Your Reference	DA 10649
Our Reference	NCA/1/2021
Contact	Deepa Randhawa
Telephone	9806 5248
Email	drandhawa@cityofparramatta.nsw.gov.au

COUNCIL COMMENTS: M2 Motorway Epping Digital Advertising Signs.

Westbound

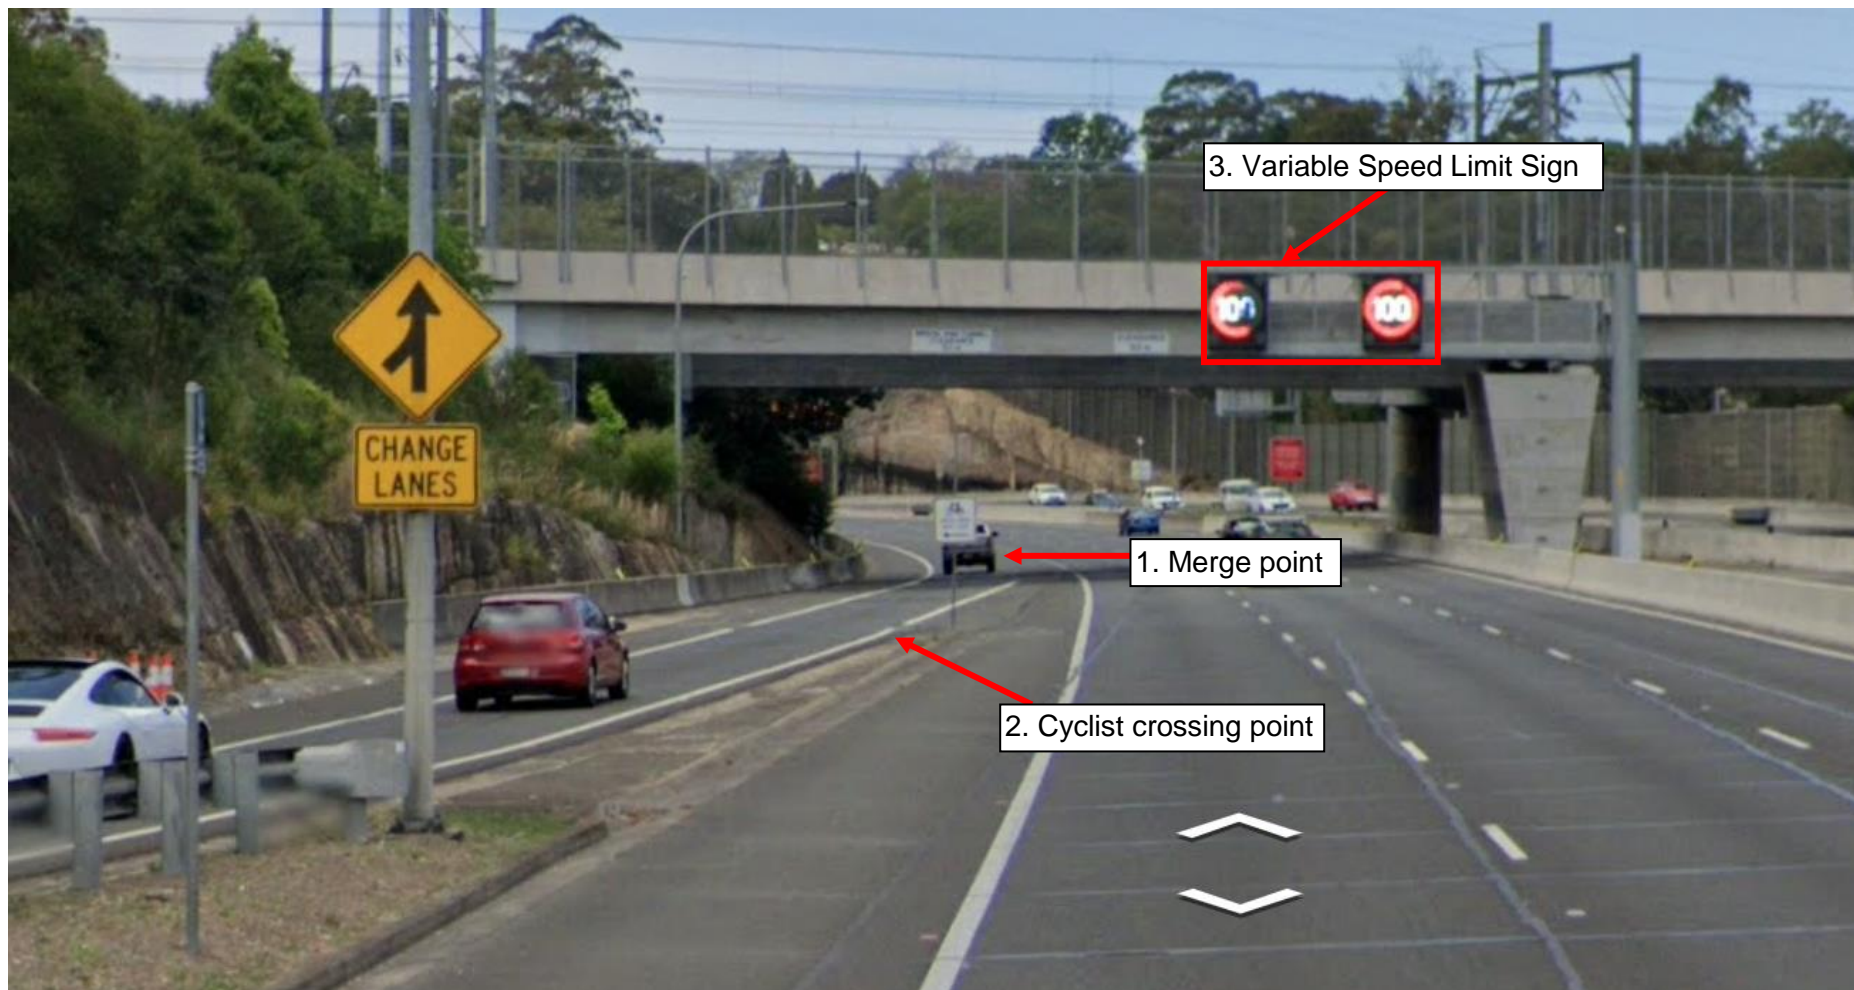
1. The diverge point of the M2 exit ramp located approximately 120m from the proposed advertising sign
2. The cyclists crossing point within the westbound exit ramp located approximately 20m from the proposed advertising sign
3. The Interchange Sequence Sign located approximately 14m from the proposed advertising sign

1. For the exit ramp, the Road Safety Assessment states that the “proposed digital signage would be located beyond the exit ramp, and thus, would not be situated within the safe sight distance”. This point is refuted as the diverge point of the exit ramp from the motorway is located at only 120m away from the proposed advertising sign with the sign in clear view of drivers. This means that it is in fact located can be viewed at a point where vehicles can suddenly change lanes to exit the motorway.

2. In regard to the cyclists crossing point on the off-ramp, the Road Safety Assessment takes the same approach as for the cyclist crossing point for eastbound traffic in that it is located outside of the minimum SSD. As stated above, this point is refuted as the crossing point is only 20m away from the proposed sign and located where motorists have a clear view of the sign. Therefore, motorists may become distracted and fail to detect any cyclists that may be crossing the road.

3. In regards to the interchange sequence signs, the report Road Safety Assessment claims that the advertising sign will not obstruct the drivers view. However, although the advertising sign is not physically obstructing the existing sign, it is still in very close proximity and may

cause an information overload for the driver causing them to miss key information regarding the approaching road environment to allow them to safely navigate the road.

Eastbound

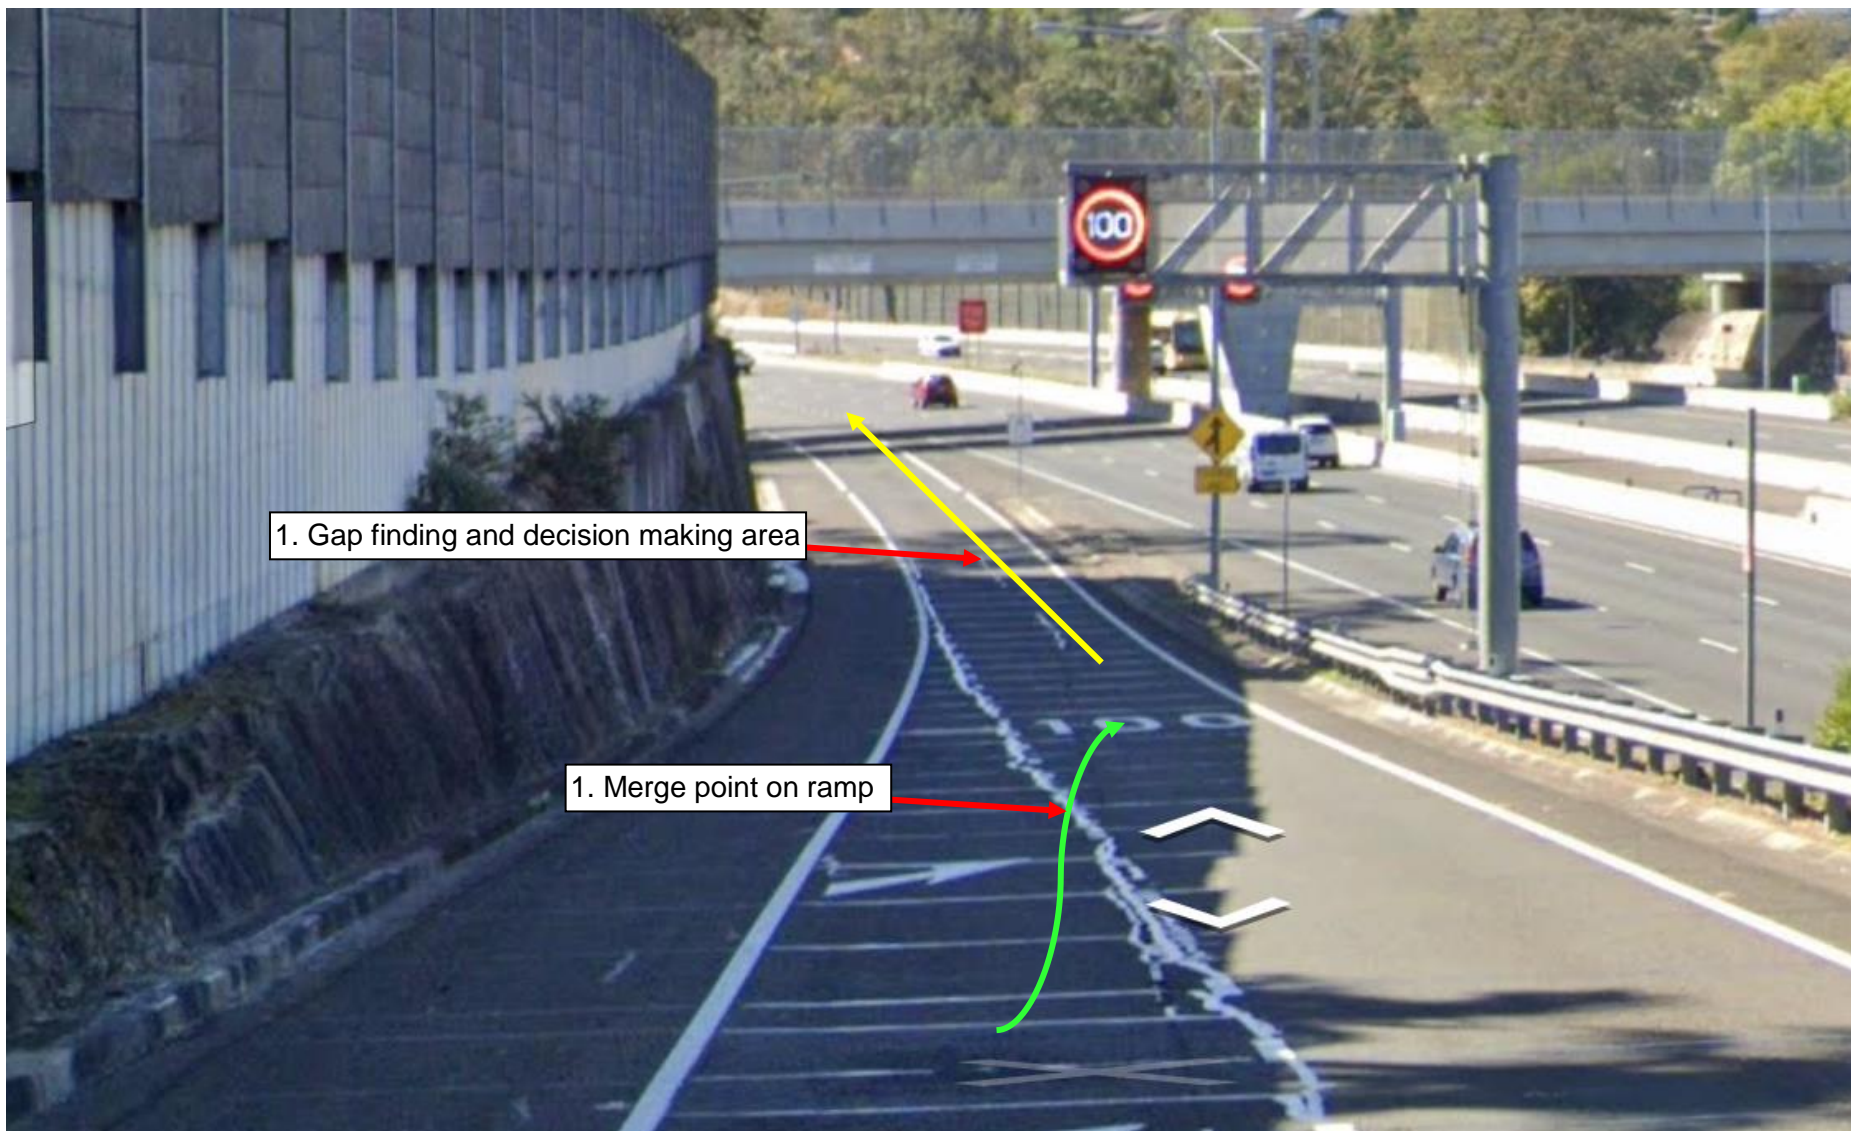
1. The merge point of the M2 on ramp is located approximately 15m beyond the proposed advertising sign and the gap finding and decision making occurs on the approach to the proposed sign
2. The cyclists crossing point within the eastbound on ramp is located approximately 40m from the proposed advertising sign
3. The Variable Speed Limit Signs are located approximately 35m from the proposed advertising sign

1. For the on ramp, the Road Safety Assessment for eastbound traffic states that "the beginning of the merge point is located beneath the railway bridge and beyond the visible

distance of the digital signage” and that the “driver’s attention will not be focused on the signage since it will be out-of-view for the driver” to argue that the signage will not be expected to affect road safety. However, the decision making and gap finding occurs on the ramp on the approach to the main traffic lanes occurs and on the approach to the proposed sign. The sign would be a distraction during this approach. This applicant’s assessment also does not consider the merging on the on-ramp where vehicles merge into one lane. The proposed sign will be in view of the driver at the point where they may be required to make a decision to merge on the ramp.

2. In regard to the cyclists crossing point, the Road Safety Assessment argues that the “digital signage location is beyond the cycle crossing point and would not be positioned within the minimum SSD”. This point from the report is refuted as the crossing point is only 40m away from the proposed sign and therefore will be in view of the drivers. As such, this proposed sign could distract drivers and cause them to fail to detect any cyclist that may be crossing the road.

3. The Road Safety Assessment states that the advertising sign will be positioned behind the variable speed limit sign. This point from the report is noted however, both the variable speed limit sign and the advertising sign are in a similar line of sight and at times may have very similar colour contrast. This will cause the variable speed limit sign to become obscured and may cause the driver to miss the speed limit or be distracted by the advertising.
